# 112 2<sup>nd</sup> Avenue E – New Storefront and Window (H24-057-COA)

CITY OF HENDERSONVILLE - COMMUNITY DEVELOPMENT - HISTORIC PRESERVATION  
COA STAFF REPORT

**Project Type:** Storefront Replacement and Window Replacement

Current doors located on 2<sup>nd</sup> Avenue E.

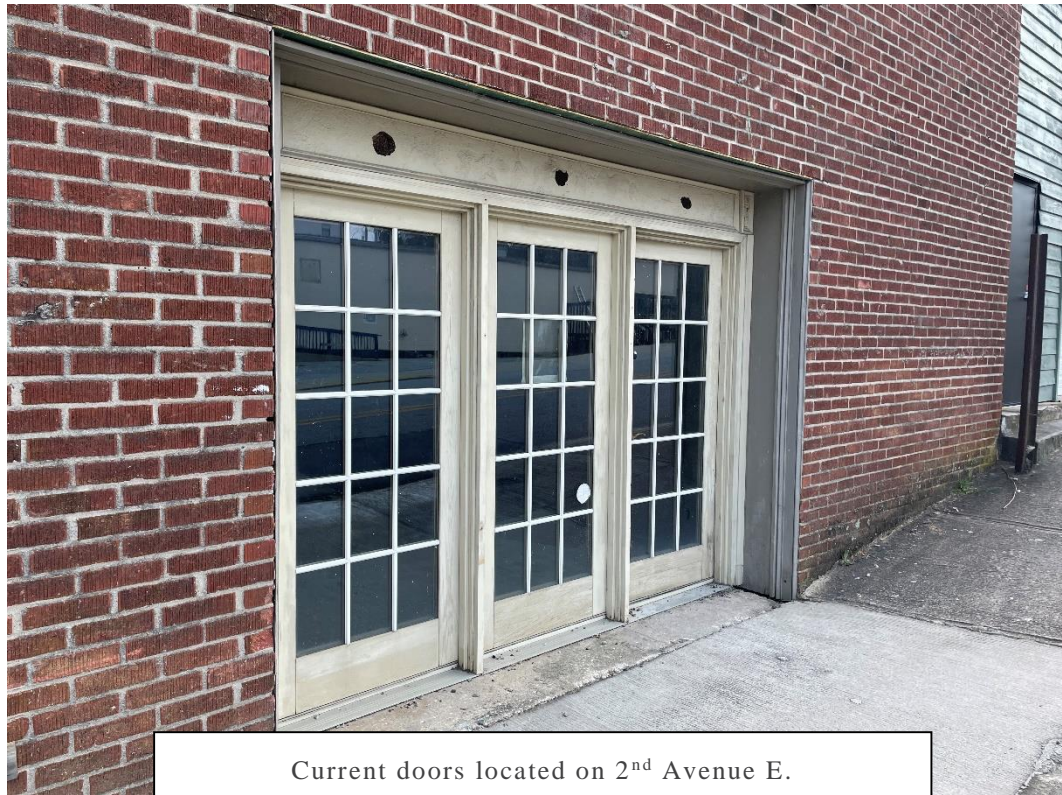
The City of Hendersonville is in receipt of a Certificate of Appropriateness (COA) application from Katie Montes for the installation of storefront doors in a building on 2<sup>nd</sup> Avenue E. The doors utilize the existing opening and are made out of black metal. The existing doors do not appear to be original, however, it is unknown when they were installed.

Existing window opening located on King Street.

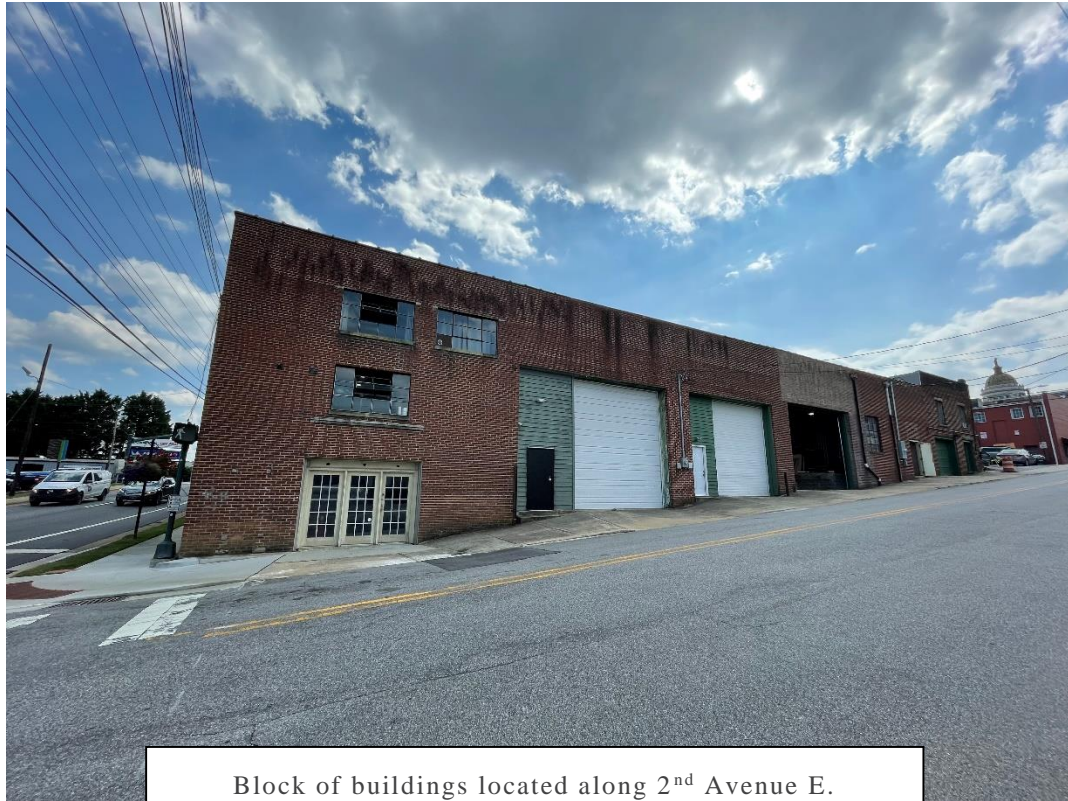
The applicant has also requested approval to install a garage door on the east side of the building. It is unclear from the application if the garage door will be operational. It is also unclear if the door will also be black metal, and what the reflection will be on the windows.
